RESOLUTION NO. R 2361

A RESOLUTION OF THE CITY COUNCIL OF THE CITY OF KIRKLAND APPROVING THE ISSUANCE OF A PLANNED UNIT DEVELOPMENT AND INTENT TO REZONE AS APPLIED FOR IN DEPARTMENT OF COMMUNITY DEVELOPMENT FILE NO. R-PUD-76-20(P) (FINAL) BY PUGET SOUND LAND ASSOCIATES TO DEVELOP 168 APARTMENTS AS A FINAL PUD AT N.E. 132nd STREET AND 125TH AVENUE N.E., BEING WITHIN AN RS 35,000 ZONE, AND SETTING FORTH CONDITIONS TO WHICH SUCH REZONE AND FINAL PLANNED UNIT DEVELOPMENT SHALL BE SUBJECT.

DEPARTMENT OF COMMUNITY DEVELOPMENT
ADVISED REPORT
FINDINGS, CONCLUSIONS AND RECOMMENDATIONS

CITY COUNCIL AS INCORPORATED IN	ORDINANCE
R-2361 RESOLUTION	—
NUMBER	—
APPLICANT	John Stuart/Puget Sound Land Associates
PROPERTY LOCATION	N.E. 132nd St. and 125th Ave. N.E.
SUBJECT	Appl. for Rezone, Final Planned Unit Development and Informal Subdivision for "Salish Village Apartments"
HEARING/MEETING DATE	—
BEFORE	—

SALISH VILLAGE Phase I

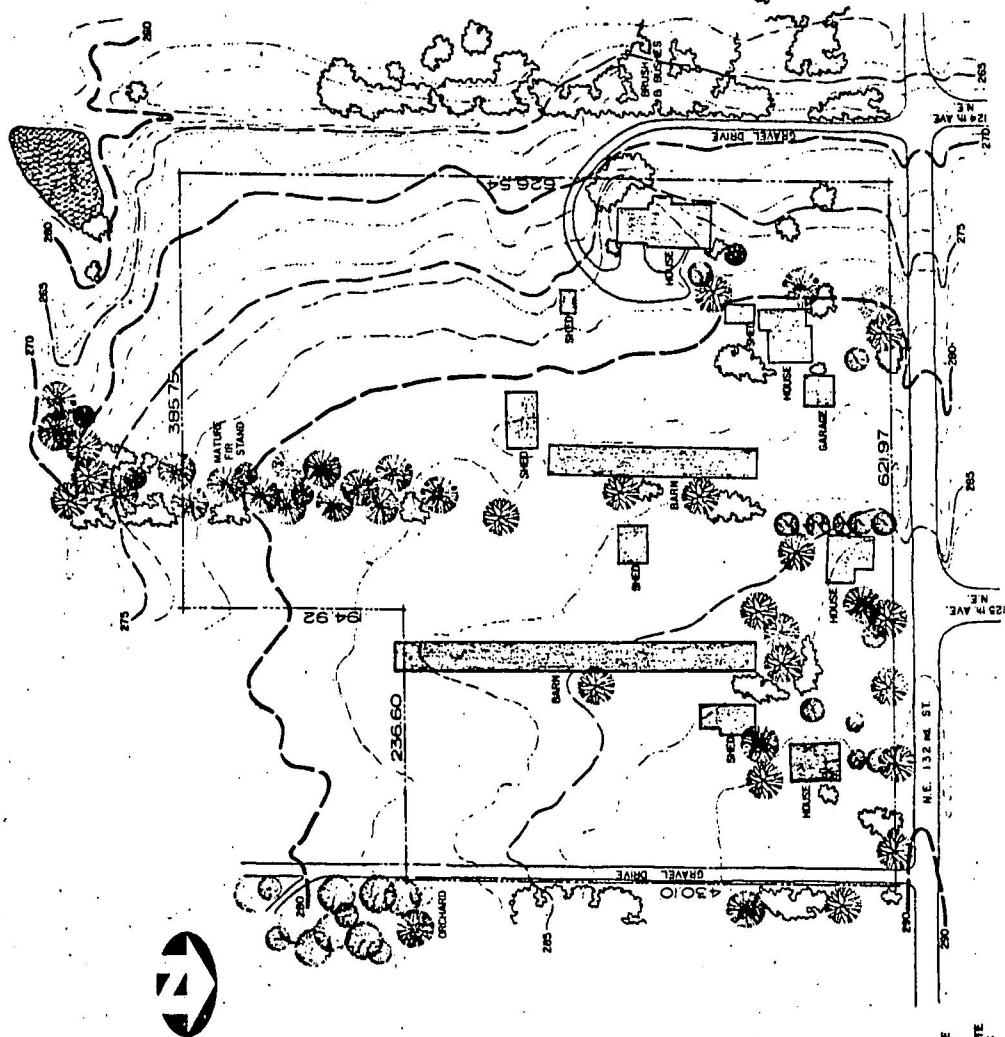
Soils Conditions

The Soil Survey for King County, Washington, as issued by the Washington State Department of Natural Resources, states that the soils within the scope of the project as described below are sandy loam, rolling, well-drained on a slope. A detailed description of the soil is as follows: The soil is unconsolidated, talus or glacial till of considerable thickness. This till is a hard, dense, unsorted cemented mixture of clay, silt, sand and gravel. Foundation conditions are expected to be excellent due to the proposed piling on bedrock.
